# COMMENT SHEET

## East High Streetscape Project

PROJECT NUMBER: U000-104-298, PE-101, RW-201, C-501

Wednesday, June 12, 2019

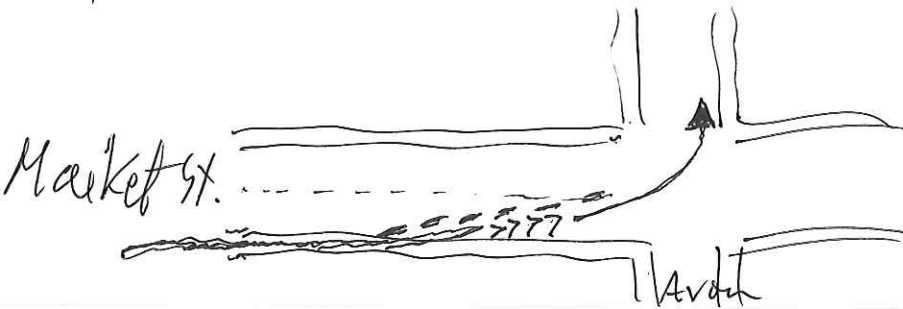
*Much of the east-bound bike traffic on Market St. will want to turn left onto Nineth Street. Below is what I've seen in NYC @ RT intersections where a majority of cyclists turn left:*

*9th St.*
